MONITORING YEAR 0 ANNUAL REPORT FINAL

OAK HILL DAIRY MITIGATION SITE

DMS Project No. 100120

Subject: Oak Hill Dairy Draft MY0 Report Review
Catawba River Basin – CU# 03050102
Gaston County
DMS Project ID No. 100120
Contract # 7867

1
Figure 1a. Current Condition Plan View
Oak Hill Dairy Mitigation Site
DMS Project No. 100120
Monitoring Year 0 - 2022
Gaston County, NC

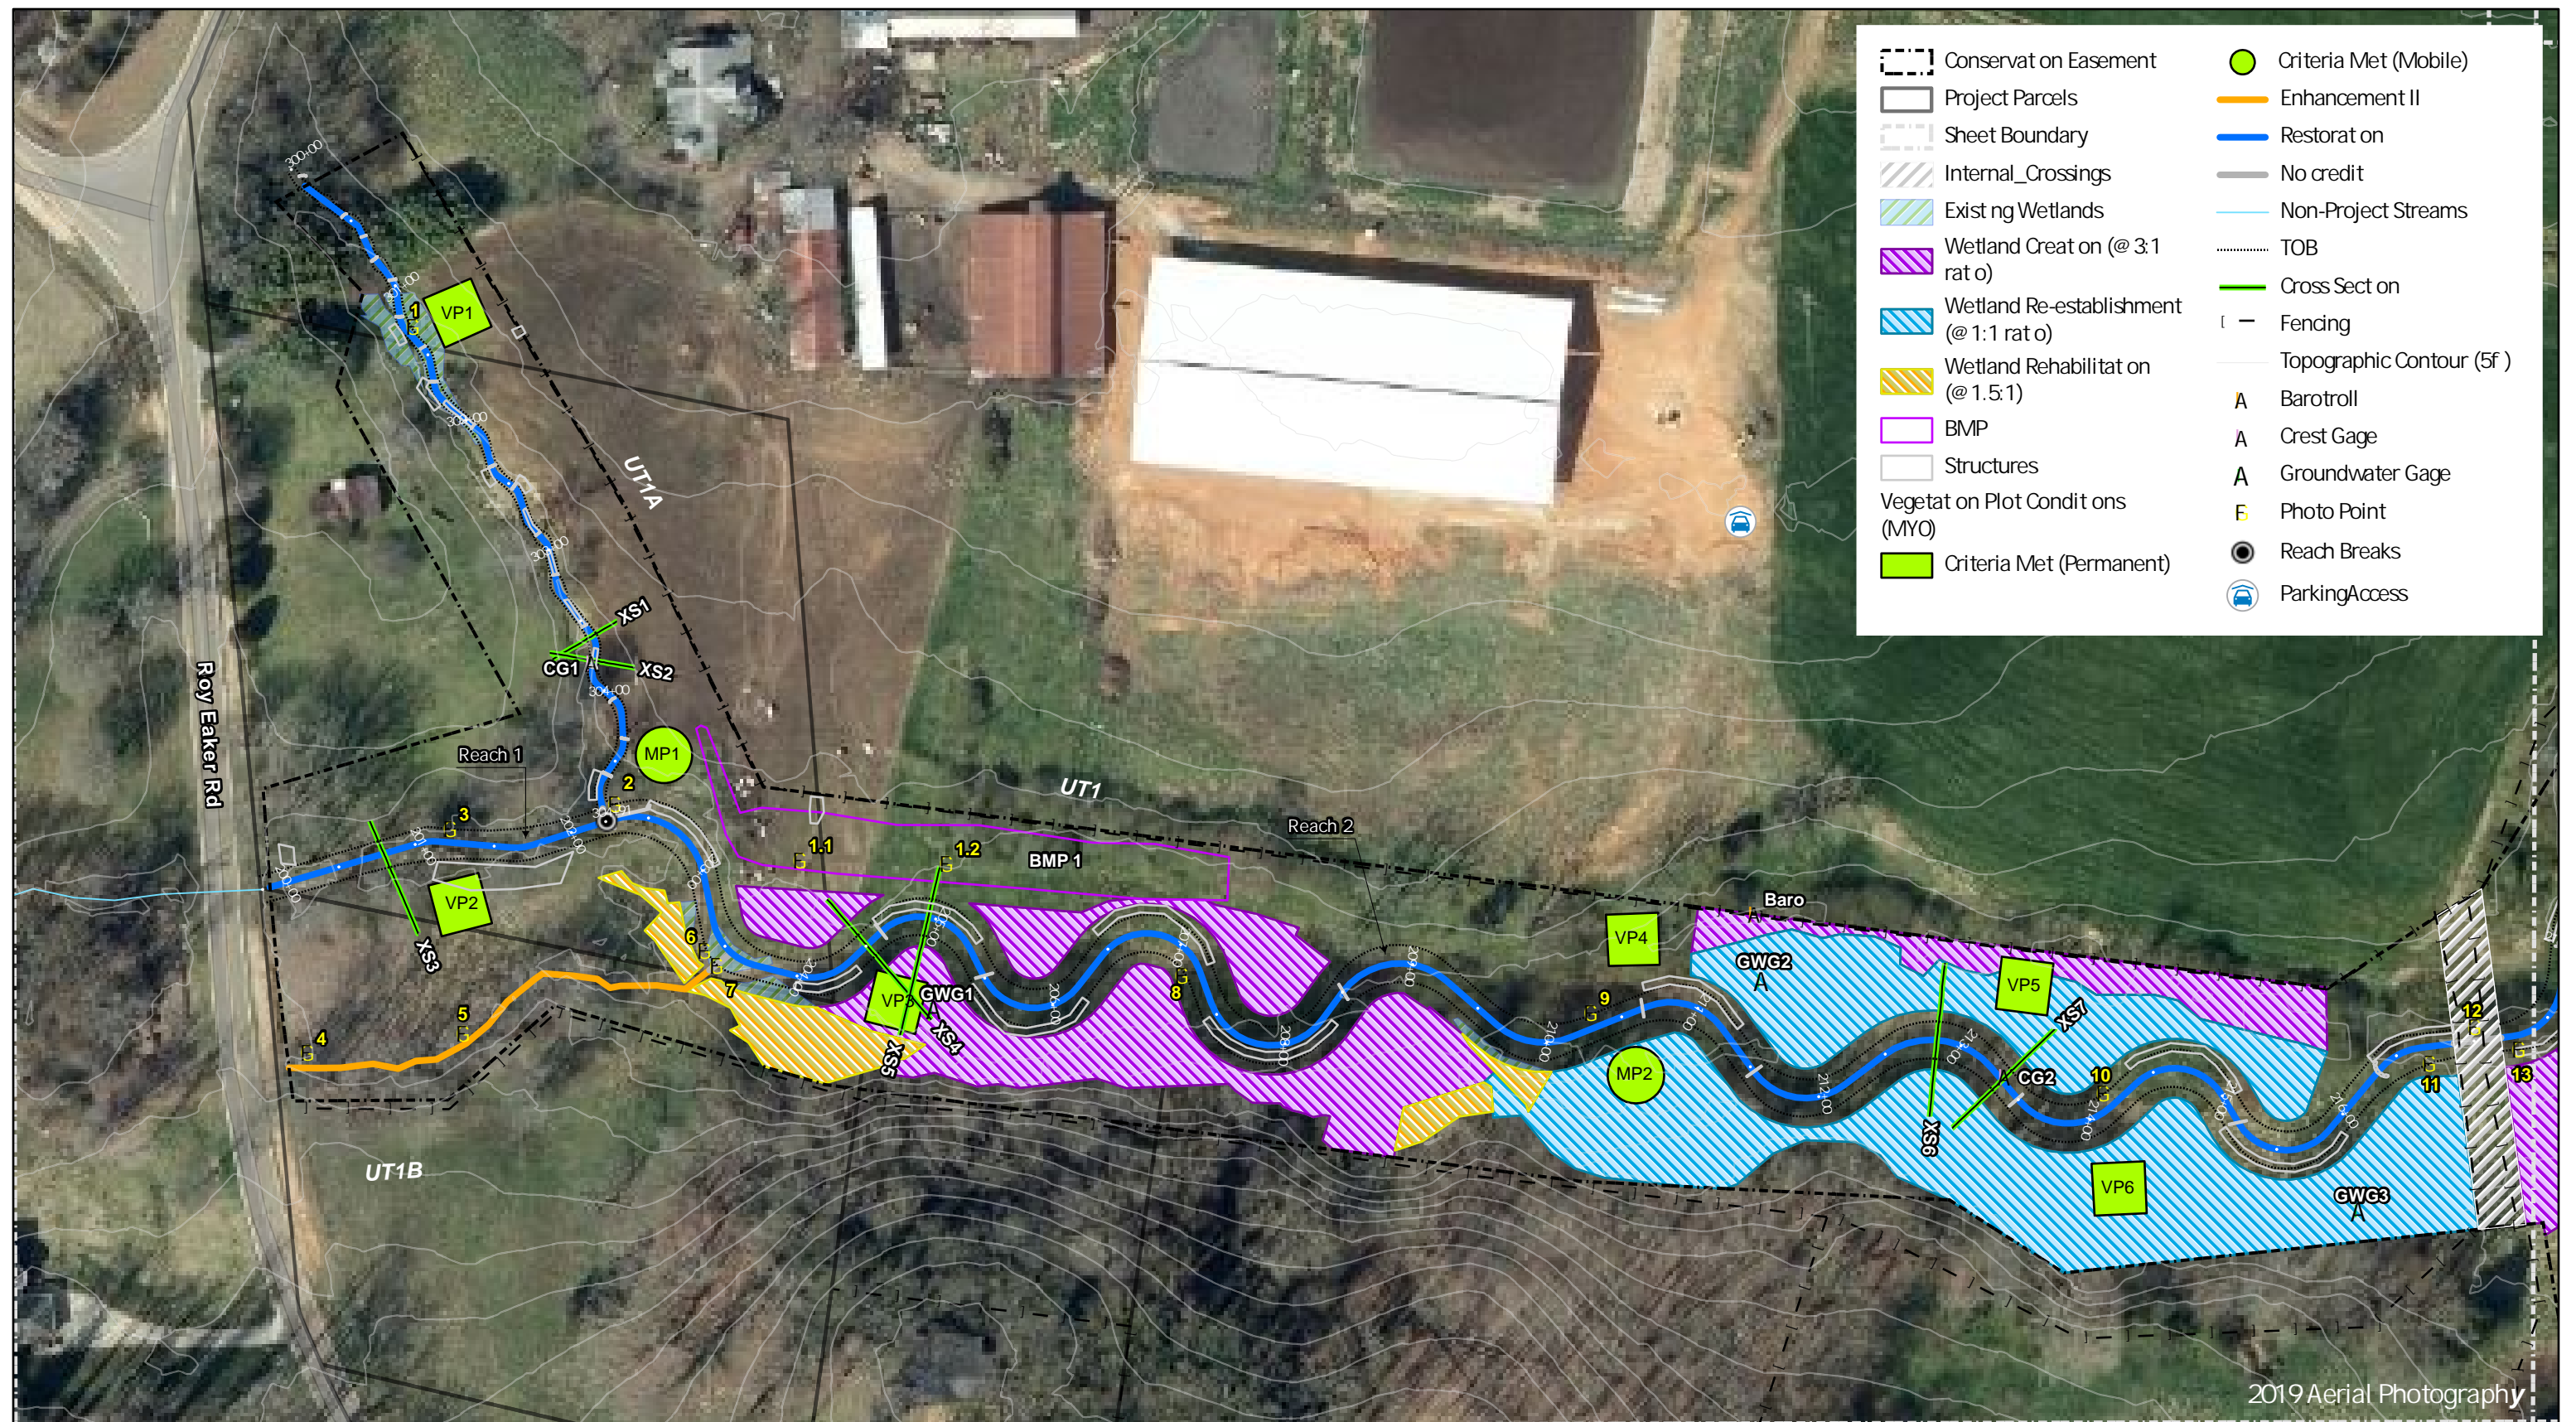
- CCPV: Recommend labeling BMP1 and BMP2.
- Photos of BMP1 and BMP2 show a considerable amount of ponded water. Does WEI expect the BMPs to hold water year-round or dry seasonally?

Wildlands Response: BMP labels are now shown on CCPV maps.

1.14

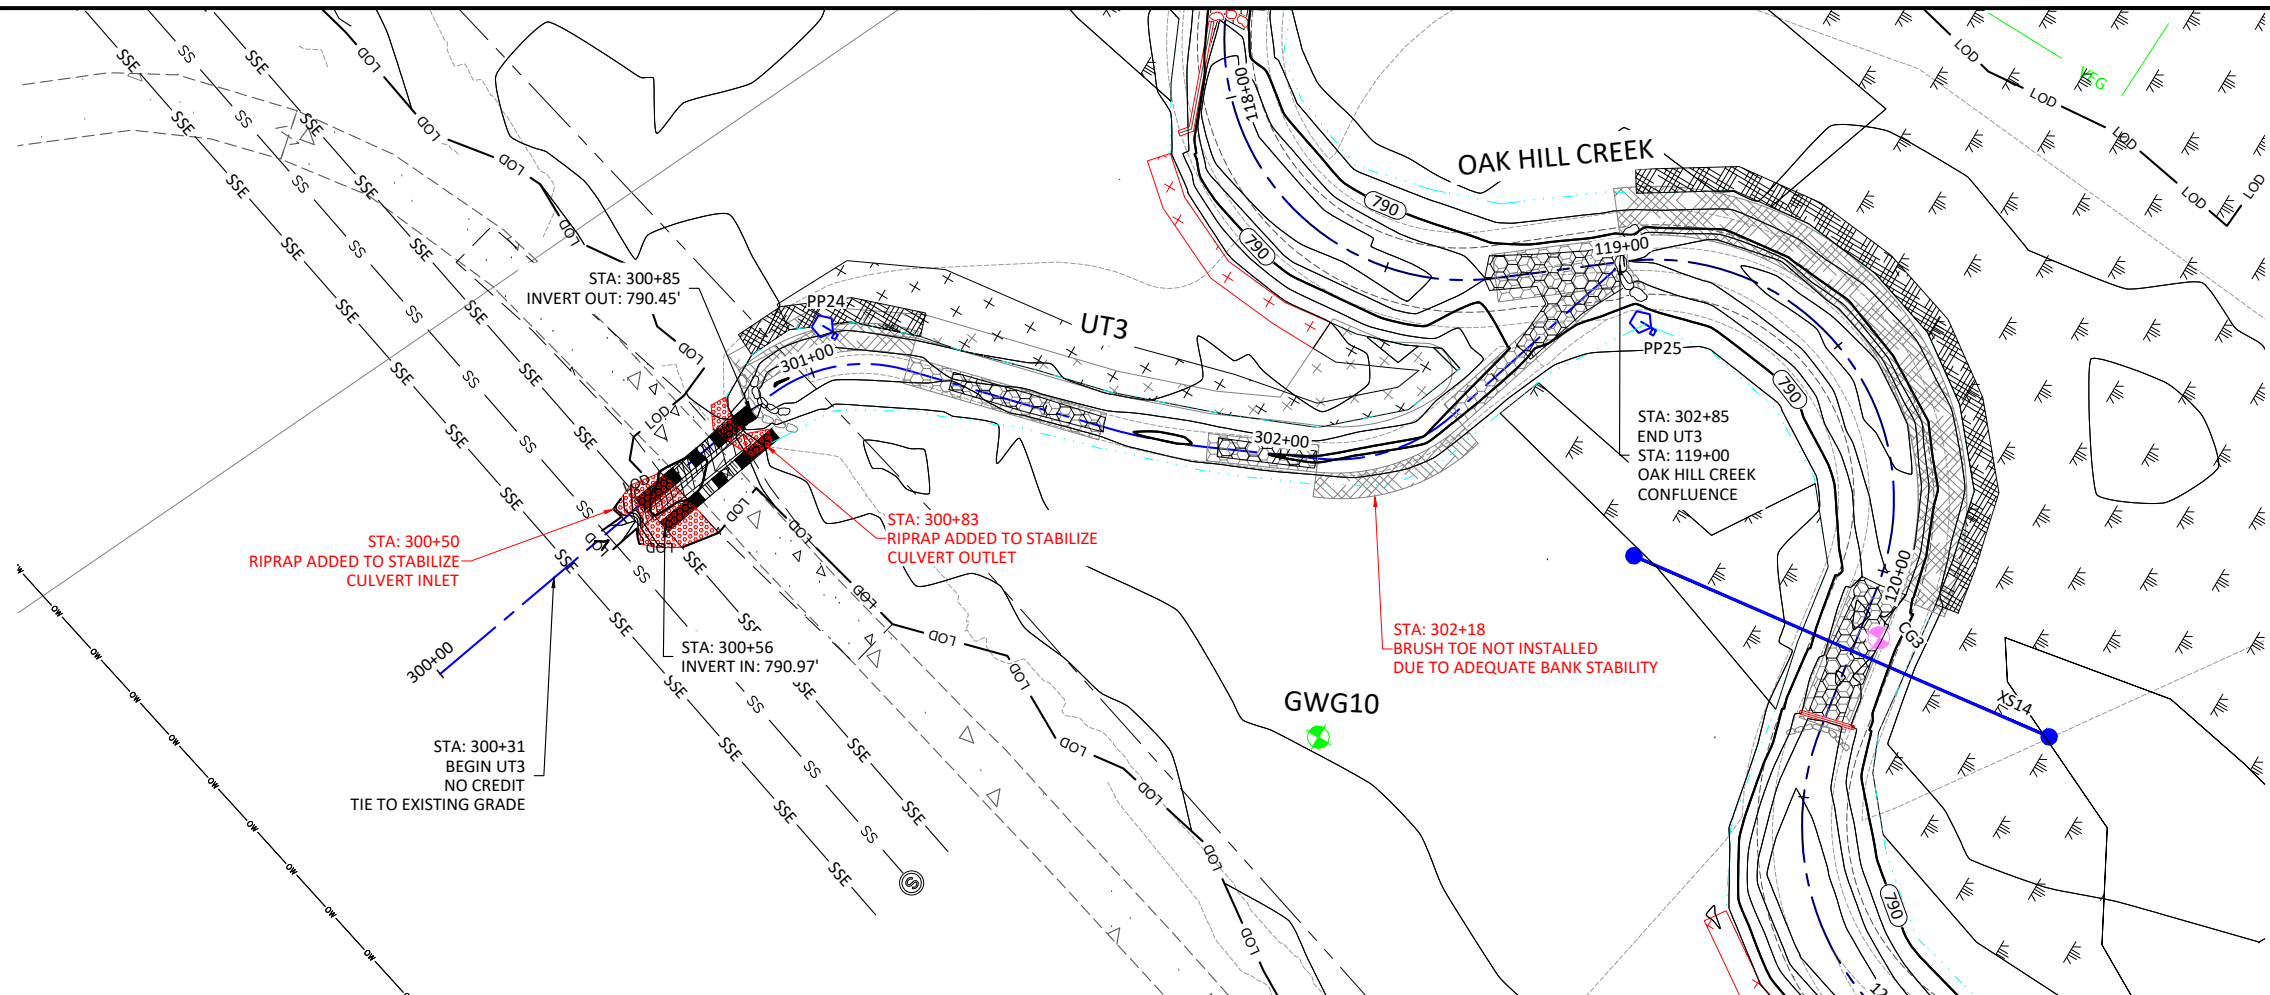
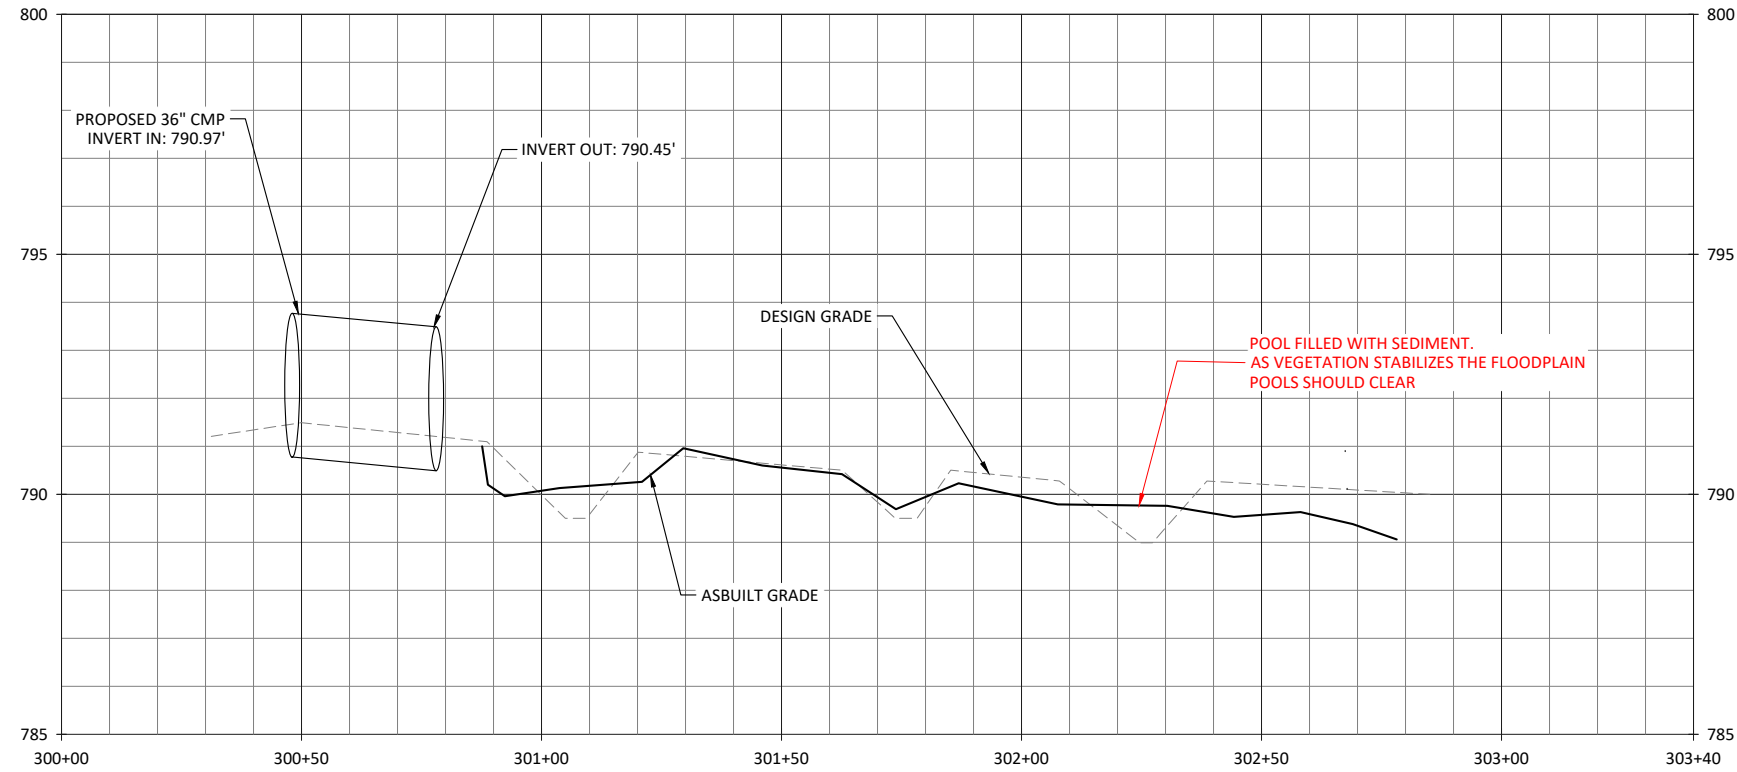
7. *Sheet 1.14: Pools on UT2 profile are shown and noted as being filled with sediment. WEI expects the pools to adjust as vegetation becomes established. Please provide an update in MY1 regarding the UT2 stream conditions. Note that UT2 is not a credited reach.*

Wildlands Response: A brief summation of UT2 stream conditions will be included in MY1.
